COBB COUNTY ZONING DIVISION  
FILED IN BOOK 11003 BBOB  
MARS HILL CHURCH ROAD TRACT

**PETITION NO:** Z-4

APPLICANT: Traton Homes, LLC

**ZONING COMMENTS:**

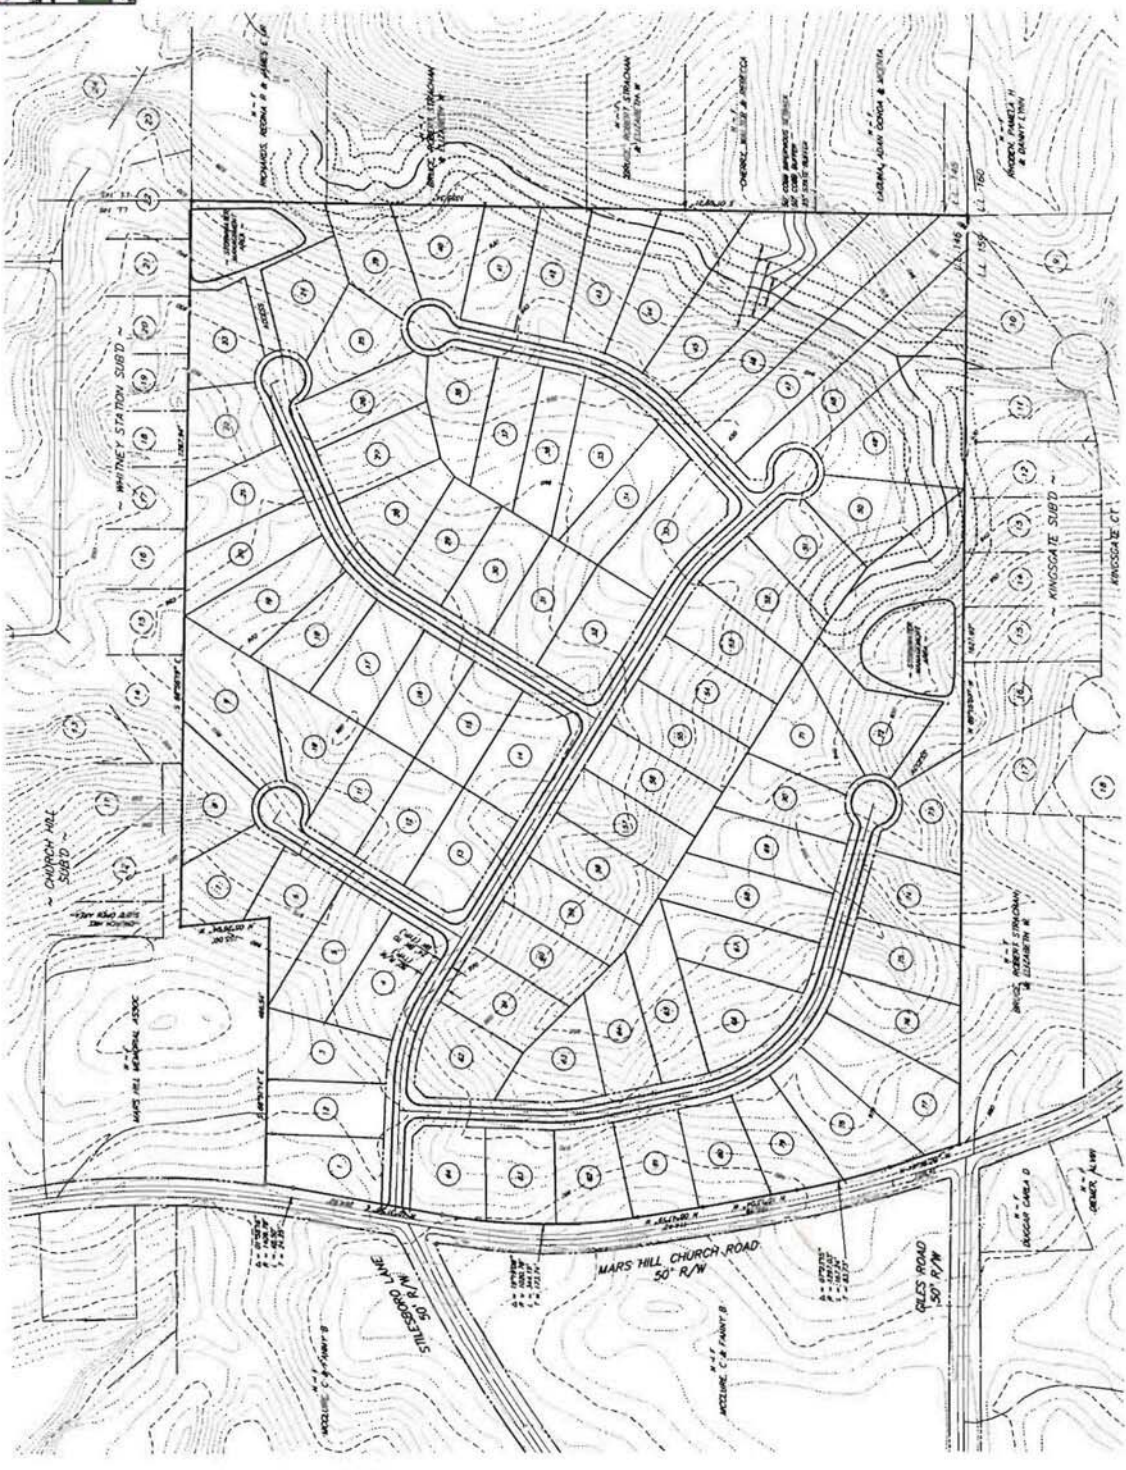
1. Proposed detention ponds are located adjacent to existing single-family residential parcels. Adequate screening must be provided to visually screen ponds from adjacent residents in KingsGate and Whitney Station Subdivisions.
2. Adequate swale and associated drainage easement must be provided along rear of lots abutting Whitney Station Subdivision to direct any offsite runoff to existing platted drainage easement(s) within Whitney Station.
